The Connecticut Light and Power Company
Docket No. 370

Data Request CSC-04
Dated: 05/07/2010
Q-CSC-006
Page 1 of 1

Data Request CSC-04
Dated: 05/07/2010
Q-CSC-007
Page 1 of 2

Greater Springfield Reliability Project
 Manchester to Meekville Junction Circuit Separation Project - Variation
 Mapsheet 10B of 11

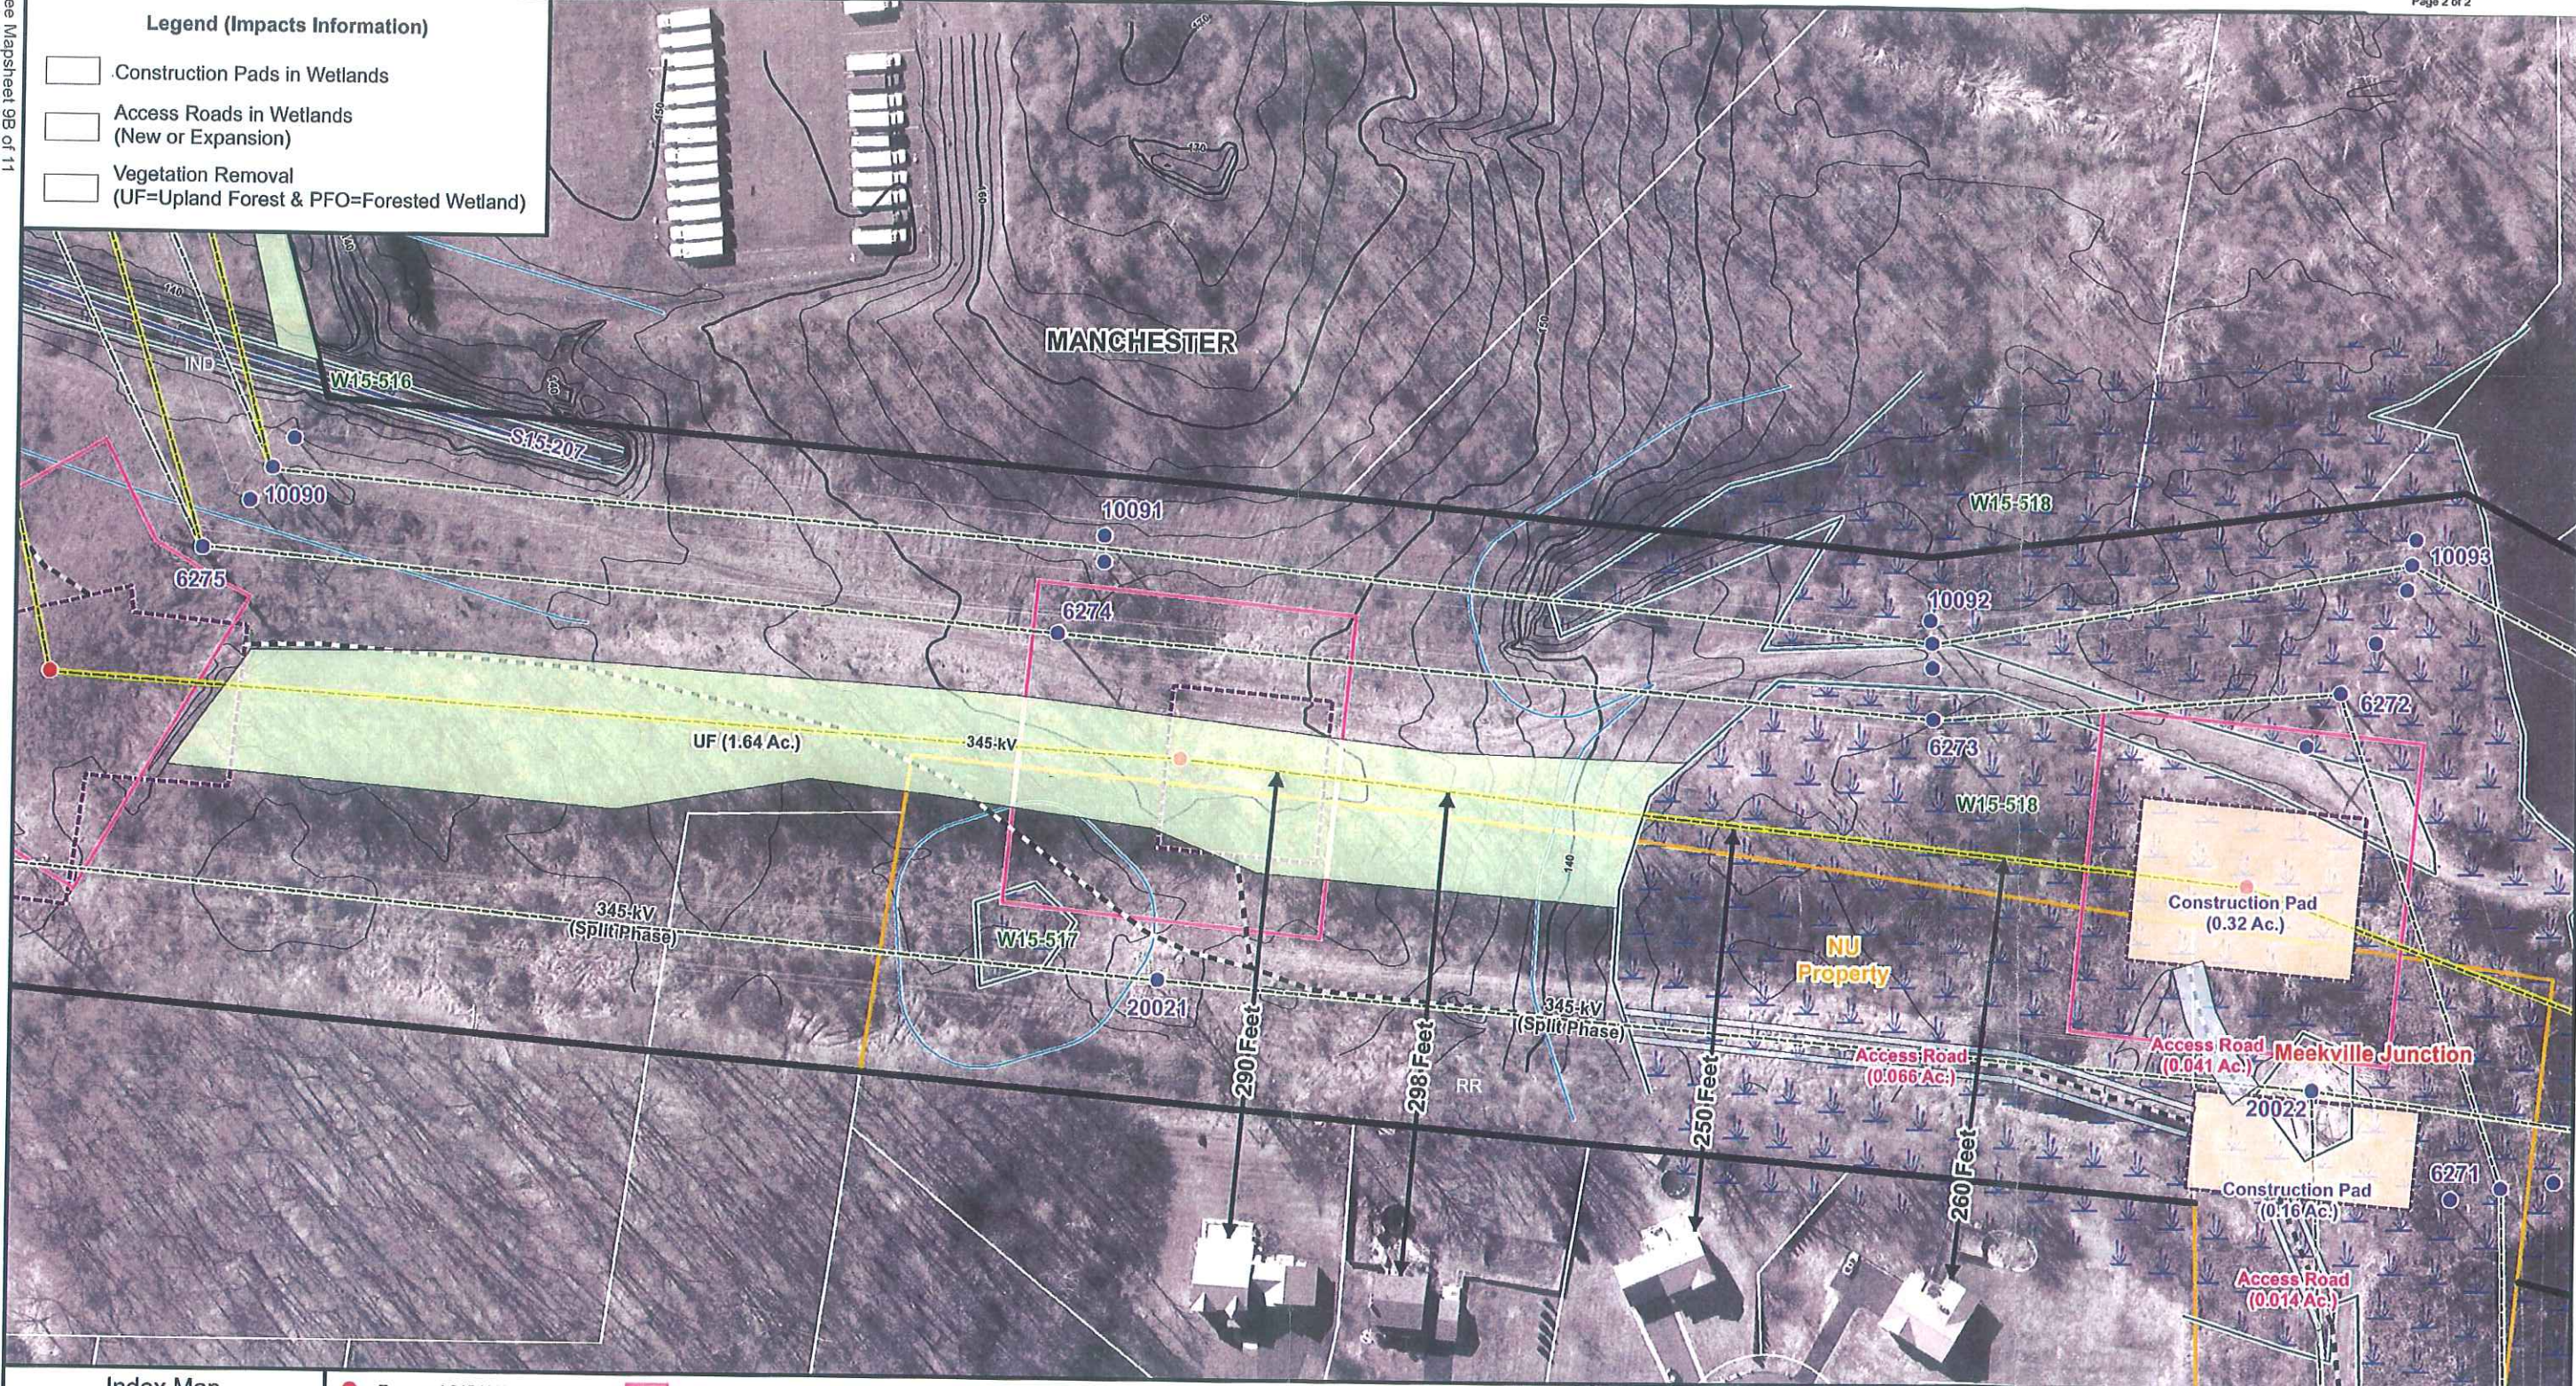
Question:
What is the approximate distance of the four residences near Cross Section 22 of the MMP-V to the proposed new line?

Response:
The approximate distances from the four residences to the new MMP-V line range from 250 to 298 feet. Please refer to the aerial photo map on page 2 of 2 for the approximate distance to the new line for each of the four homes.
